Three Mile Island Nuclear Station, Unit 1 (TMI-1)
Operating License No. DPR-50
Docket No. 50-289
Inspection Report 84-03 (Post Accident Sampling and Monitoring)

POST ACCIDENT SAMPLING AND MONITORING (IR 84-03)
OUTSTANDING ITEMS

FIGURE 1

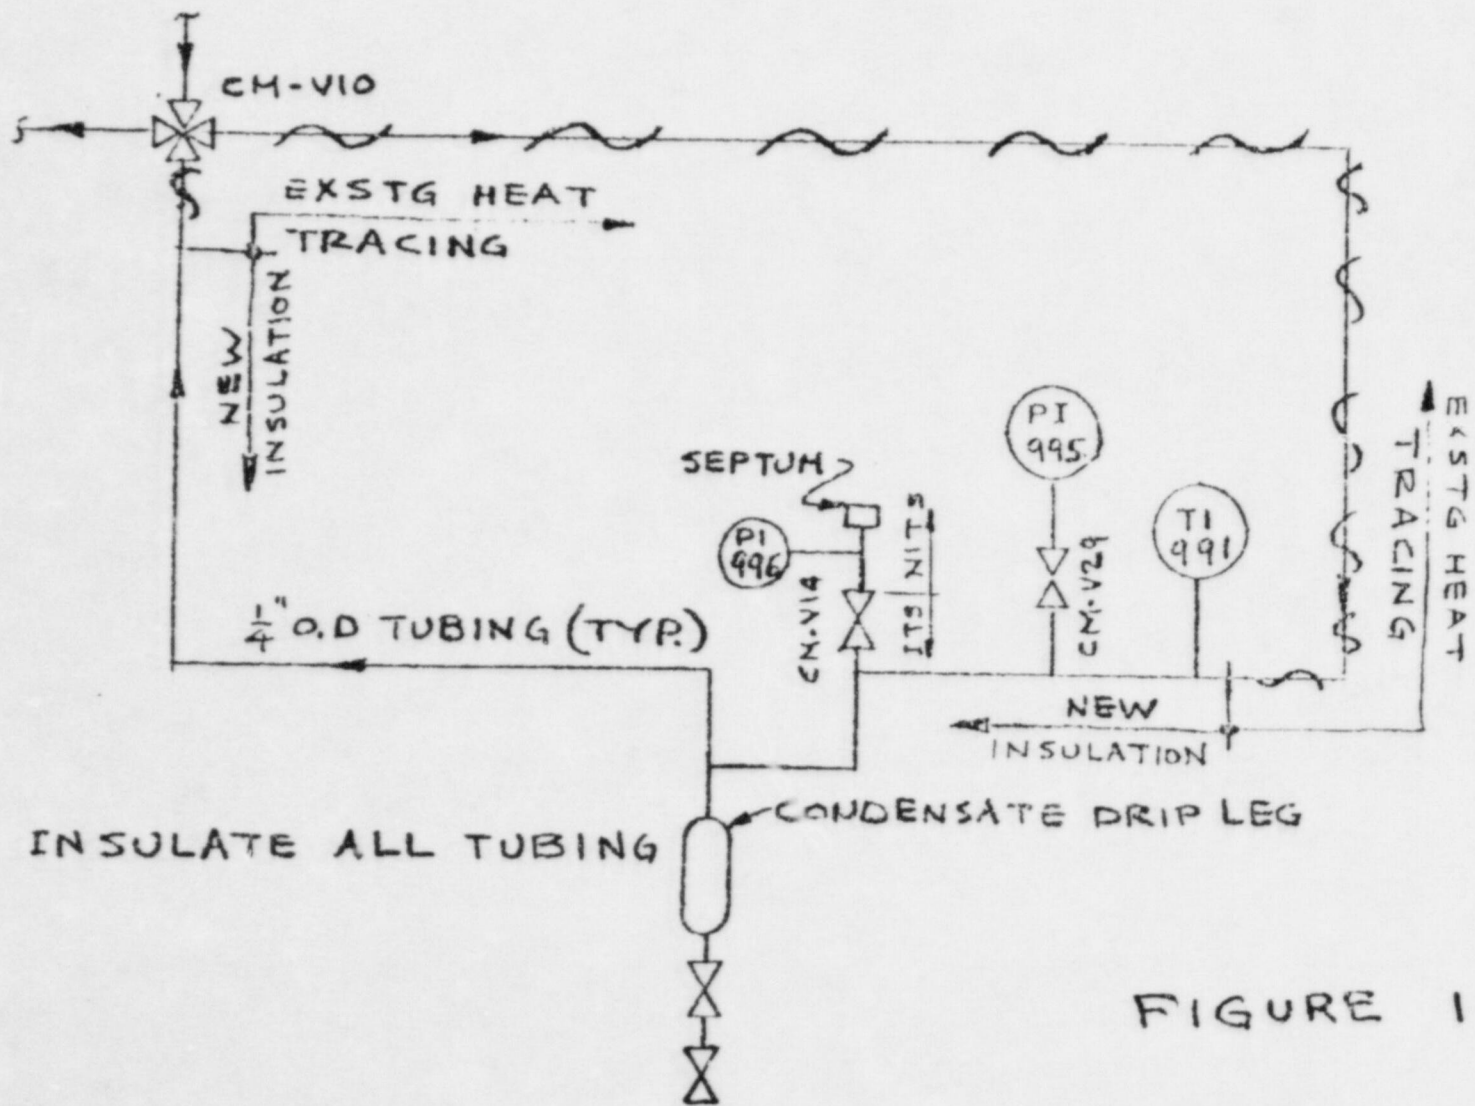
- 2.a.2 The Containment Atmospheric Post Accident Sampling System (CATPASS) will be modified to improve its operation in order to obtain a more representative sample. Basically, this will be accomplished by minimizing changes in flow rate and temperature. Modification of the CATPASS will include the following changes (See Figure 1):

- i. Insulation will be added to all tubing at the sample station to minimize heat loss.
 - ii. The sample bomb will be replaced by a septum. The sample will be obtained from the septum and transported in a syringe. Removal of the sample bomb will eliminate a change in velocity of the sample stream due to the change in cross sectional area and will reduce the internal surface area of the system at the sample point. This will reduce the possibility of condensation and plateout of iodine.

- iii. The sample point (septum) will be located as close as possible to the point where heat tracing ends in order to minimize heat loss at the sample point. The septum will be orientated in such a manner as to prevent any condensation which might be present in the tubing lines from entering the sample. Pressure tests on the septum will be required in accordance with the CATPASS System Design Description to evaluate leakage characteristics and to establish the pressure rating and replacement requirements for the septum.

- iv. The following will be eliminated from the system: solenoid valves (CM-V12 & 13), pressure reducing valve (CM-V25), pressure switches (PS-998 & 999), pressure indicator (PI-997), flow indicator (FI-837) and isolation valves (CMV-11, 34, 35, 36 & 37). This will eliminate heat sinks and points of possible condensation.

- v. Porcelain insulators will be added to the tubing supports to minimize heat loss through the supports.
 - vi. A condensate drip leg will be added downstream of the sample point to remove any condensation which might be present.

2.a.3 The following is a description of the operation of the CATPASS on completion of the modifications described in 2.a.2:

Post accident containment atmosphere will be sampled using the existing sample and return lines for radiation monitor (RM-A2). Three-way valves will valve out RM-A2 and direct the sample through heat traced tubing lines to the sampling station. Control of these valves will be from the local control panel. An eductor pump, using either plant instrument air or bottled air/nitrogen, will provide the motive force for obtaining the sample. Instrument air or bottled air/nitrogen will also be used for purge and pressure test.

The sample station will be provided with a temperature indicator, high range pressure gauge, low range pressure gauge, septum, condensate drip leg, and drain valves. The pressure gauges and septum will each be provided with isolation valves.

Sample flow will be directed from recirculation to the sample station by three-way valves controlled from the local control panel. Sample temperature and flow indication will be provided at the local control panel. When flow to the sample station has been established for sufficient time to ensure a representative sample, the sample will be withdrawn from the septum using a syringe and transported to the laboratory for analysis.
